Kimmage to City Centre Core Bus Corridor Scheme

NTA Observations on the Proposed Scheme Section 51

June 2024

Figure 2-9-5: Proposed Scheme Layout at Leonard's Corner Junction

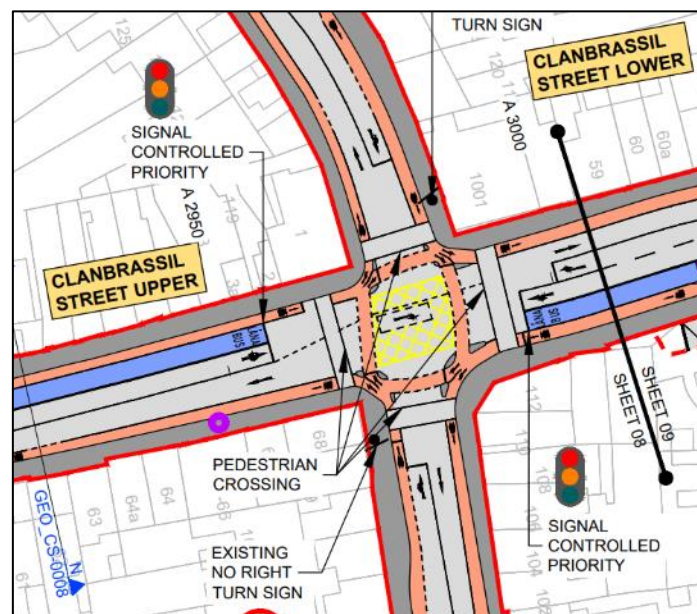
1. *"The provision of footpaths designed to the minimum width may not be sufficient in areas of high pedestrian traffic, particularly in urban villages and busy commercial streets, e.g. the footpath on Clanbrassil Street Lower (Sheet 09) and Harold's Cross Road (Sheet 07)."*
2. *"The removal of the footpath on Harold's Cross Road at the northern side of the park (Sheet 06) is generally not supported. If it is not possible to retain the footpath, it is suggested that the design of the junction of Harold's Cross Road and Kimmage Road Lower could be reviewed to provide a new pedestrian crossing running north-south on Kimmage Road Lower and into a proposed new entrance into the park."*
3. *"Footpath widths also need to account for congregations of passengers waiting in the vicinity of bus stops."*

The Proposed Scheme consists mainly of modifications to the traffic layout along existing streets and roads. The existing footpaths are largely unaffected in the scheme proposals, and it was a key consideration not to reduce the existing footpath widths unless absolutely necessary. The existing footpath widths within the proposed scheme are generally more than satisfactory for the pedestrian traffic, which varies considerably along the various streets and roads. In the busiest parts of the route in Kimmage Village at the junction of Kimmage Rad Lower with Sundrive Road, and at the Leonard's Corner junction of Clanbrassil Street with South Circular Road (as shown in Figure 2-9-5), the footpaths are generally about 3m wide, and wider in some places.

Figure 2-9-7: Snapshot from General Arrangement Drawing Sheet No.6

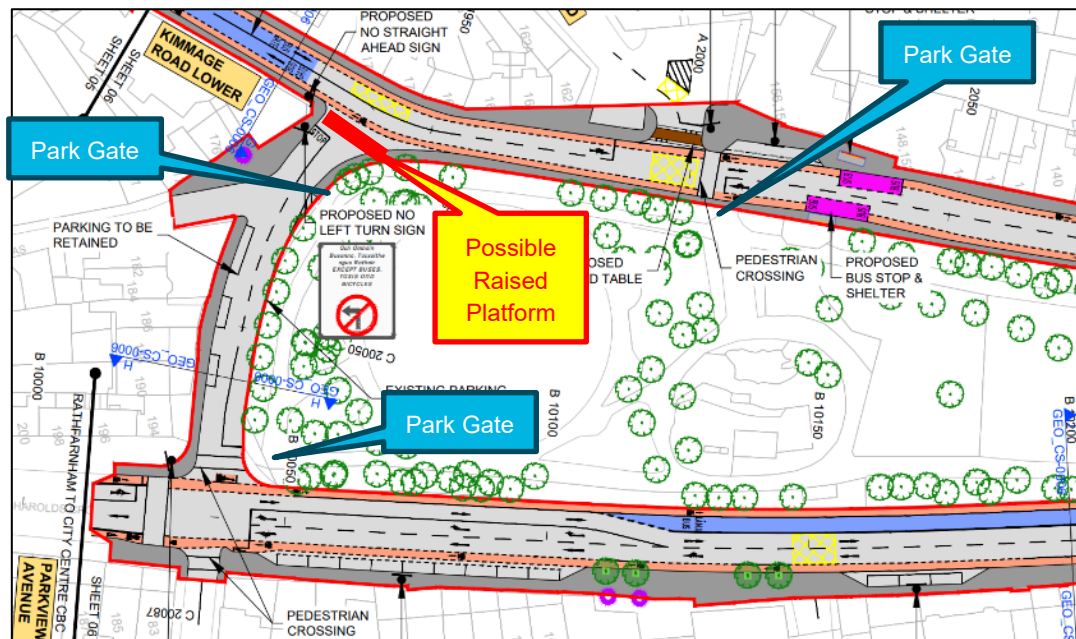
Point No.2 in respect of footpaths appears to refer to the short link street at the southern end of Harold's Cross Park (not the northern end of the park) between Kimmage Road Lower and Harold's Cross Road as shown in Figure 2-9-7. In the Proposed Scheme this short link street will be widened on the northern side to accommodate two-way traffic properly, alongside the retention of existing on-street parking for the houses on the southern side. The widening will require removal of the existing footpath along the northern side of the road adjacent to the park. The alternative option of removing the existing parking on the southern side of the street would adversely affect the amenity of the residents of the period houses, most of which do not have driveways for off-street parking, in a context where there is a general severe lack of alternative parking available in the area.

This section of street carries a very small flow of traffic at present, but that will increase slightly due to the proposed bus gate on Kimmage Road Lower at the northern end of the park, which will divert local access traffic around the southern end of the park towards Mount Jerome Cemetery, Mount Argus Road and homes opposite the western side of the park. There are three existing gates into the park as shown on Figure 2-9-7, including one at the southwestern corner. NTA accepts the suggestion by DCC Architect's Division that an improved pedestrian crossing could be provided at the junction at the western end of the link street where it joins Kimmage Road Lower, and this is indicated as a red line for a raised platform which would operate as a "courtesy crossing" as described in the *Design Manual for Urban Roads and Streets (DMURS)*.

Figure 2-10-1: Junction of Kimmage Road Lower and Ravensdale Park

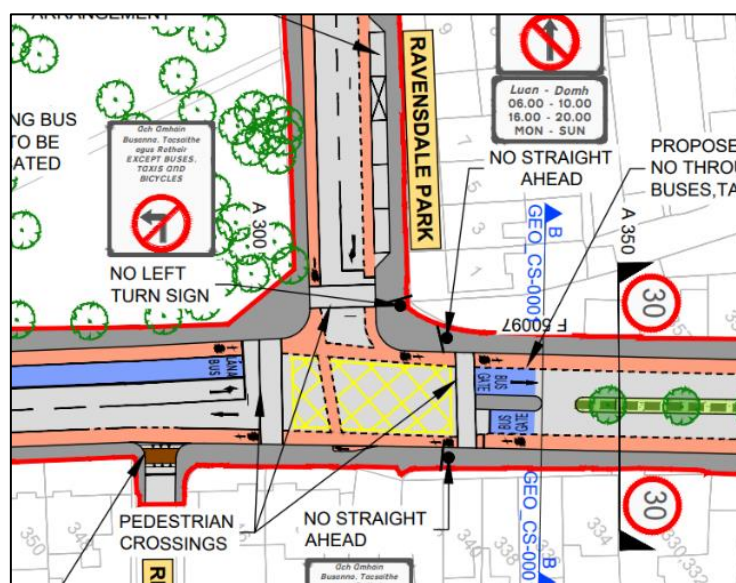
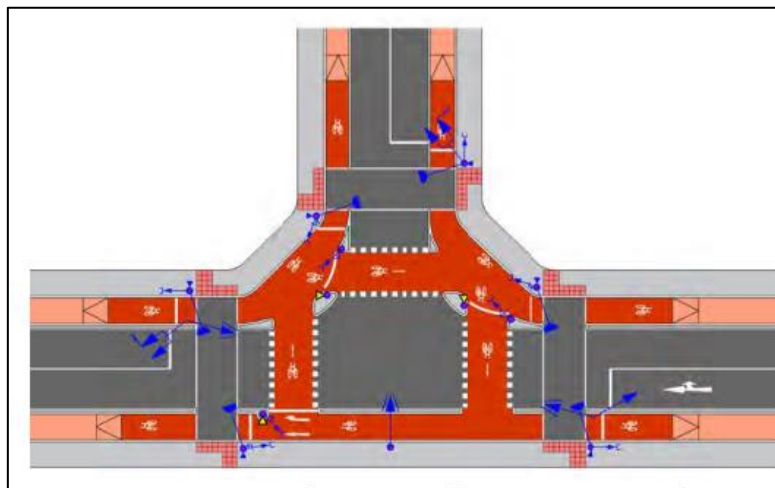
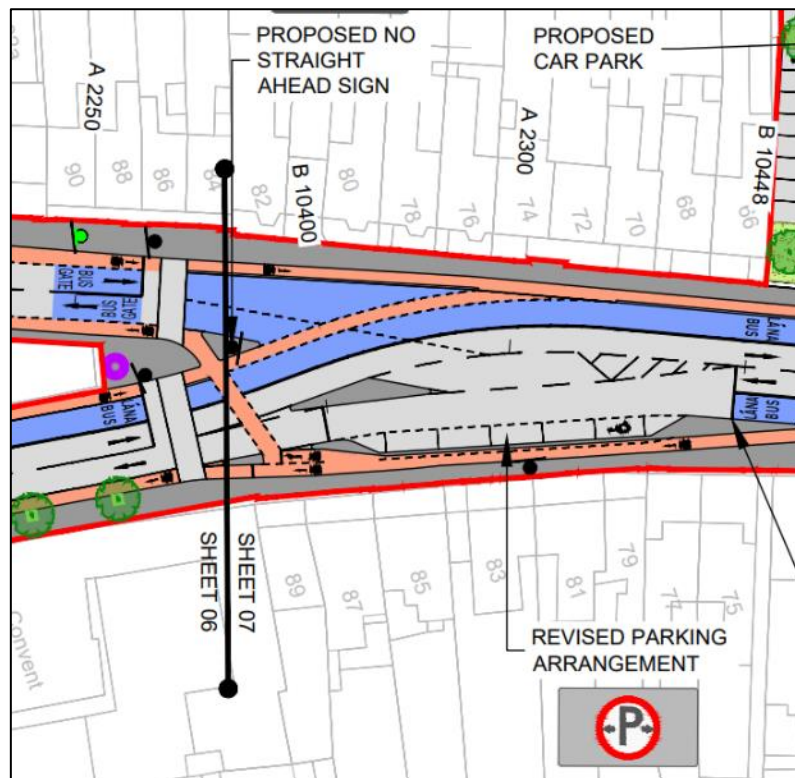
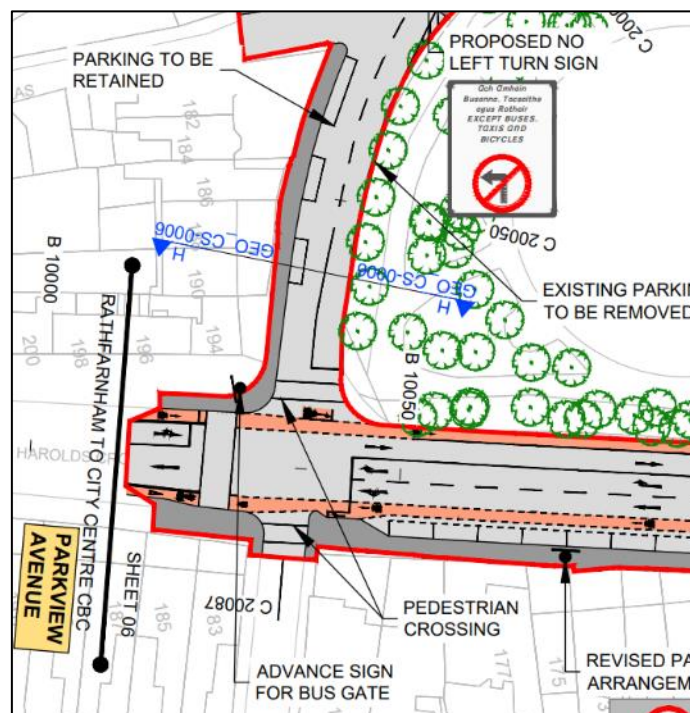
The submission states that the provisions for cyclists at three particular junctions do not fully comply with the Cycle Design Manual with insufficient segregation for cyclists at Ravensdale, Mount Argus View and Harold's Cross Road / Kimmage Road Lower. The Proposed Scheme design at these three junctions is shown in Figures 2-10-1, 2-10-2 and 2-10-3, followed by a discussion about the provisions for cyclists.

Figure 4.90 shows an arrangement at a tee-junction where there are segregated cycle tracks on both the main road and side road, which is not the case at the Mount Argus Vie junction on Kimmage Road Lower. In the Proposed Scheme the provision of bus gates on Kimmage Road Lower will remove through traffic and greatly reduce the volume of traffic along the road to a very low flow for local access only. In addition, a 30 km/h speed limit will apply. The context for cycling in these low-flow and slow conditions will be appropriate for shared use of the road without need for segregated cycling facilities. In this context the Proposed Scheme will exceed the requirements of the *Cycle Design Manual* in that separation islands are proposed at the junction with Mount Argus View, despite the benign traffic conditions. In the southbound direction a separator island will provide a protected facility for right-turning cyclists to access Mount Argus View and to continue on the parallel *Poddle Way* cycle route to Sundrive Road via the *Stone Boat Boardwalk*.

The proposed design as shown in Figure 2-10-3 is similar to the example in Figure 4.92 of the *Cycle Design Manual* (below).

The existing junction layout at Kimmage Road Lower / Harold's Cross Road has traffic signals with two pedestrian crossings on the southern arms of the Y-junction. This arrangement is retained in the Proposed Scheme. As may be seen in Figure 2-10-3, there is a fairly complex arrangement proposed on the northern arm of the junction with an advance signal for buses to cross from the bus lane on the left side of the southbound traffic lane, and to pass through the proposed bus gate at the start of Kimmage Road Lower. A separate signal crossing is proposed for cyclists to make the same movement

The existing junction of Kimmage Road Lower and Park View Avenue is priority-controlled with a pedestrian signal crossing on the southern arm on Harold's Cross Road. In the Proposed Scheme this junction will be fully signal-controlled with a new southbound right-turn lane that will accommodate traffic towards Mount Jerome Cemetery, Mount Argus Road, and the western side of Harold's Cross Park, as this traffic will be diverted away from Bus Gate No.3 at the northern end of the park. This right-turn can operate at the same time as the pedestrian crossing on the southern arm of the junction, which will be advantageous for the operation of the junction. There is no existing footpath on the western side of Harold's Cross Road along the side of the park, and the main desire line for pedestrians is to cross Harold's Cross Road at the southern side of the junction at Park View Avenue. It is preferable therefore not to provide an additional pedestrian crossing on the northern side of this junction.

Figure 3-1: General Arrangements Drawing Sheet No.6 at Harold's Cross Park South

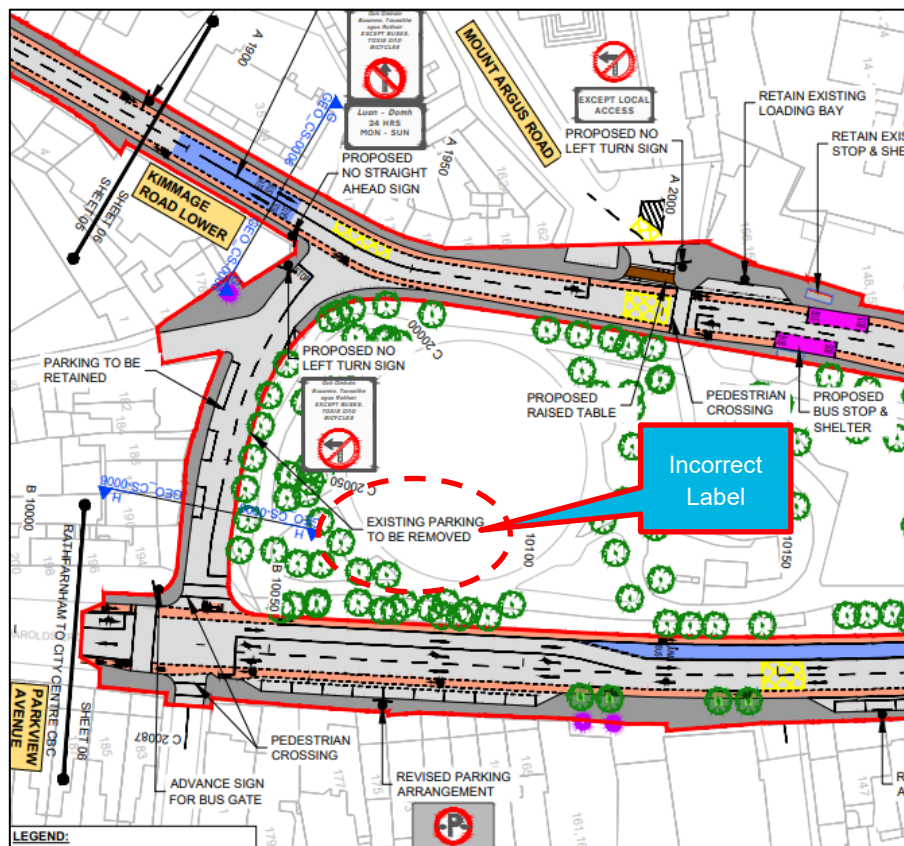
For Issue No.3 this submission says that there is an incorrect label on General Arrangement Drawing Sheet No.6 which points to "Existing parking to be removed" on the northern side of the short link street at the southern end of Harold's Cross Park. That label should say "Existing footpath to be removed". This error is corrected in this response.
